BROOKHAVEN NATIONAL LABORATORY
ASSOCIATED UNIVERSITIES, INC.
UPTON, N.Y. 11973

MONITORING SYSTEM
GUIDE

ITEM	NOTE	DATE	NAME	DIMENSIONAL OUTLINE H3171-03MOD(TAPER)		
APPROVED BY:				DRAWING NUMBER	SKETCH A	DATE	6 OCT 2000
CHECKED BY: K. Tomyama							
DRAWN BY: T. EMA	SCALE	1 / 1		HAMAMATSU PHOTONICS K.K.

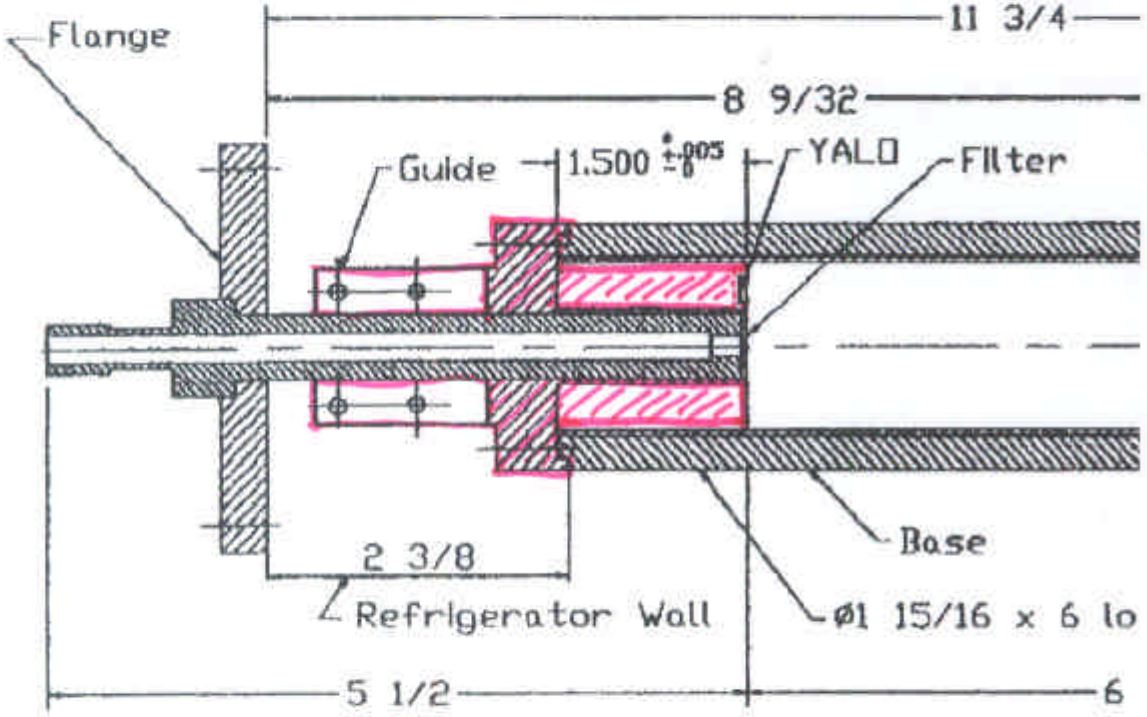
PMT positioned by "guide" part.

(in axis direction)

Thus distance between the bundle and PMT can be ~~kept~~ controlled directly.

* PMT face and end of MUmetal shield should position as shown.

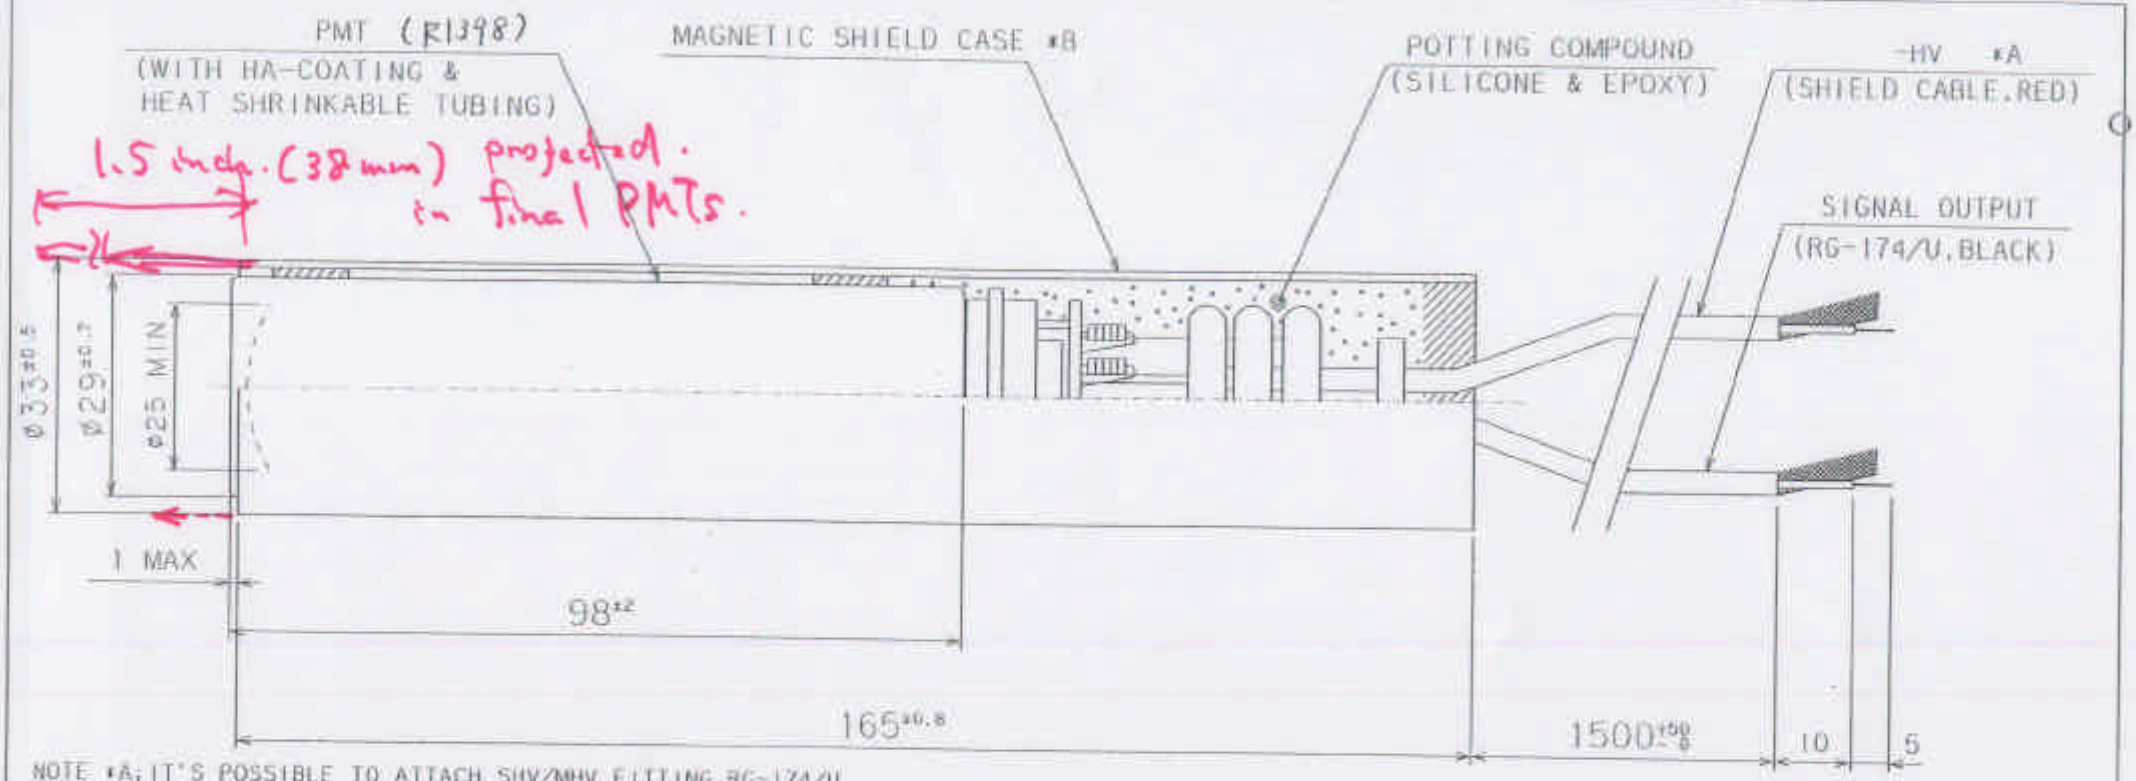
NOTE *A; IT'S POSSIBLE TO ATTACH SHV/MHV FITTING RG-174/U.

*B; IN VIEW OF MECHANISM, THIS PRODUCT IS DESIGNED FOR A WIDE USE, SO THAT DOES NOT ESPECIALLY ALLOW FOR EDGE EFFECT OF MAG SHIELD BEING SHOWN IN "PHOTOMULTIPLIER TUBE -PRINCIPLE TO APPLICATION-" PUBLISHED BY HAMAMATSU AND IN "ACCESSORIES FOR PHOTOMULTIPLIER TUBES CATALOG". IF EDGE EFFECT IS NECESSARY FOR YOU, PUT IN ADDITIONAL REQUEST, PLEASE.
